**Request for Additional Information Docket No. 71-9387**  
**Model No. Outer Package-Raw Material Shipping Container (OP-RMSC)**

By letter dated December 18, 2020 (Agencywide Documents Access and Management System Accession [ADAMS] No. ML20363A167), Industrial Nuclear Company, Inc. (INC) submitted an application for a Certificate of Compliance (CoC) for the Model No. Outer Package-Raw Material Shipping Container (OP-RMSC) transport package. This request for additional information (RAI) letter identifies information needed by the staff in connection with its review of the safety analysis report (SAR). NUREG-2216, "Standard Review Plan for Transportation Packages for Spent Fuel and Radioactive Material," was used by the staff in its review of the application.

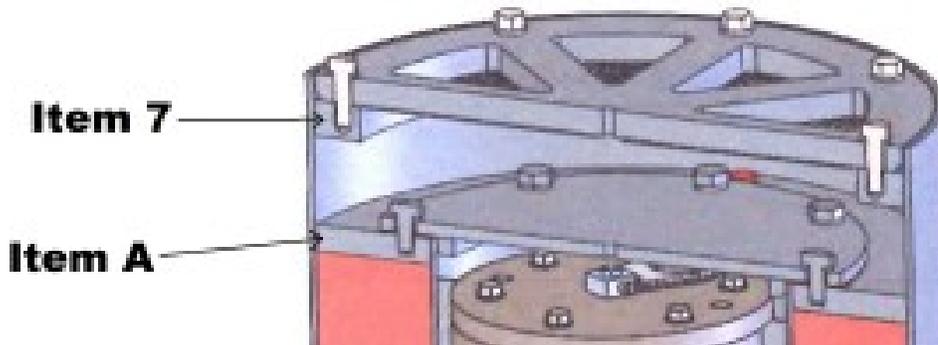
1.1. Provide component dimensions.

SAR Drawing OP-RMSC-SAR-TA, page 1 of 4 identifies seven stainless steel plates used to fabricate the Outer Pack-Raw Material Shipping Container (OP-RMSC). Based on staff's review of the drawings, two of the seven steel plates have both an outer diameter and an inner diameter. However, staff only identified one steel plate (i.e., Item 7) with both an inner and an outer diameter listed on drawing OP-RMSC-SAR-TA, page 1 of 4. Since the steel plate in question is also numbered incorrectly on OP-RMSC-SAR-TA, page 2 of 4 (see RAI 1.2), staff has identified the plate in question as "Item A" in the figure below. Staff needs this information to ensure correct fabrication of the package.

**Response:** INC Drawing OP-RMSC-SAR-TA, Rev. 1 has been revised to correct and add the requested information. Item A in the above figure is Item 1, which now includes both the outer and inner diameter dimensions, on this drawing. The views on subsequent sheets have also been corrected.
